Access Compliance Report

Public Rights-of-Way

Intersection ID: 6218	Main Street: BEAM_LAKE_DR	Cross Street: PEACHWOOD_DR	Location: NE
ADA ID: 322B6510464E	Ramp Type: PerpDiag	Initial Pass/Fail: Fail	Overall Compliance: No
			Severity Score: 31.25

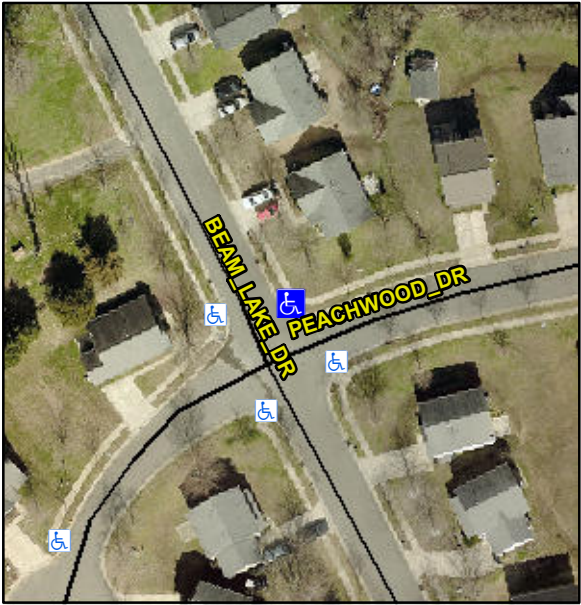
Codes/Mitigation Info/Possible Solution		Field Measurements/Component Compliance			
	Possible Solutions:				
	Remove & Replace Curb Ramp With Two New Directional Ramps or Equivalent.				
	Surveyor Notes:				
	N/A				
	PROW/ADA:				
	Not Found, R304.5.1, R304.2.2, R304.5.3				
		Compliance	Description	Data	Compliance
		N/A	Ramp Length (in)	46.0	No
		No	Ramp Width (in)	32.0	No
		N/A	Flare Type LT	N/A	N/A
		N/A	Flare Slope LT (%)	N/A	N/A
		N/A	Flare Traversable LT?	N/A	N/A
		N/A	Landing Length (in)	N/A	N/A
		N/A	Landing Width (in)	N/A	N/A
		N/A	Landing Slope (%)	N/A	N/A
		N/A	Landing X Slope (%)	N/A	N/A
		N/A	Landing Curb? (Y/N)	N/A	N/A
		N/A	Shared Landing?	N/A	
		N/A	Gutter Ponding?	N/A	N/A
		N/A	Gutter Lip Ht (in)	N/A	N/A
		N/A	Painted X Walk1?	No	N/A
			X Walk 1 Direction	To NW	X Walk 2 Direction
		N/A	X Walk 1 Width (in)	N/A	N/A
			X Walk 1 Slope (%)	3.4	X Walk 2 Slope (%)
			X Walk 1 X Slope (%)	3.7	X Walk 2 X Slope (%)

N/A	Ramp inside XWalk1?	N/A	N/A
			Road Slope (%)	2.9	N/A
			Road X Slope (%)	0.8	N/A
		N/A	Any Obstructions?	N/A	N/A
			Obstruction Type		
				N/A	N/A
				Yes	Surface Condition? (G/P)
					Good
